HISTORIC AND DESIGN REVIEW COMMISSION

December 15, 2021

HDRC CASE NO: 2021-613
ADDRESS: 201 ISABEL ST
LEGAL DESCRIPTION: NCB 3978 BLK 4 LOT 18
ZONING: R-6, H
CITY COUNCIL DIST.: 3
DISTRICT: Mission Historic District
APPLICANT: William and Evangeline Garcia
OWNER: William and Evangeline Garcia
TYPE OF WORK: Addition
APPLICATION RECEIVED: November 19, 2021
60-DAY REVIEW: Not applicable due to City Council Emergency Orders
CASE MANAGER: Katie Totman
REQUEST:

The applicant is requesting a Certificate of Appropriateness for approval to construct an addition to the existing, historic structure to feature approximately 334 square feet. The proposed addition will be constructed to the east side of the historic structure.

NORTH ELEVATION
SCALE 3/8"=1'-0"

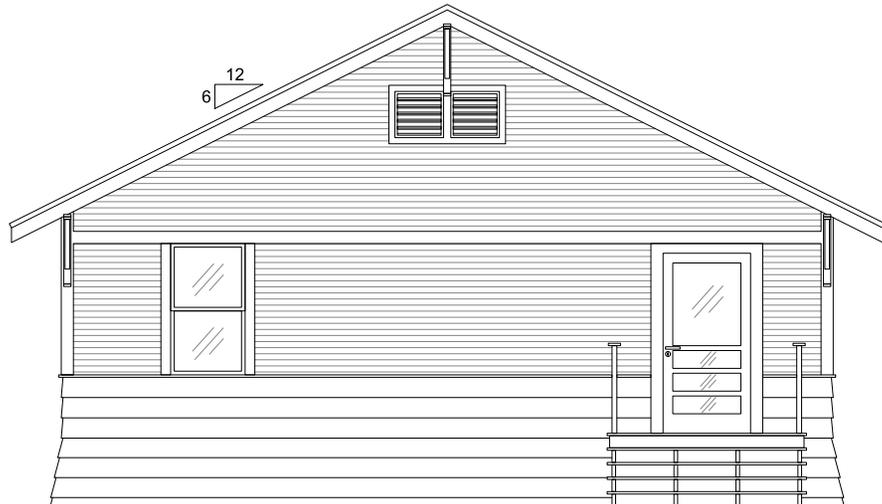
- c. **ADDITION (Setback)** - The Mission Historic District Design Manual notes that side additions must be set back from the front façade by at least fifty (50) percent of the total side façade length. A greater setback is encouraged where feasible. The applicant has proposed for the addition to be in line with the front of the primary historic structure and extending toward the east property line by 12-feet. While the general placement of the addition may be appropriate in this instance, staff finds that the addition should be set back at least 50% from the front façade of the primary structure to be consistent with the Mission Historic District Design Manual.

- d. **ADDITION (Width)** – The Mission Historic District Design Manual note that side additions must not be greater than thirty (30) percent of the width of the front façade of the primary structure. The applicant has proposed an addition that features a width of approximately 12-feet, and the width of the historic structure is approximately 26-feet. The proposed addition's width is not consistent with the Design Manual.

- e. **ROOF FORM** – Per the Mission Historic Design Manual, side additions must feature a subordinate roofline in height, while maintaining the original roof form. Ridge lines that match the existing historic structure in height may be considered on a case-by-case basis. The applicant has proposed a side gable roof with a ridge that is slightly taller than that of the historic primary structure. The proposed roof form is not consistent with the Design Manual. Staff finds that a lower, transitional roof form between the original structure and the addition be used to be consistent with the Design Manual.

- i. That the proposed addition's setback be increased to 50% of the primary structure's setback as noted in finding c.
- ii. That a lower, transitional roof form between the original structure and the addition be used as noted in finding e.
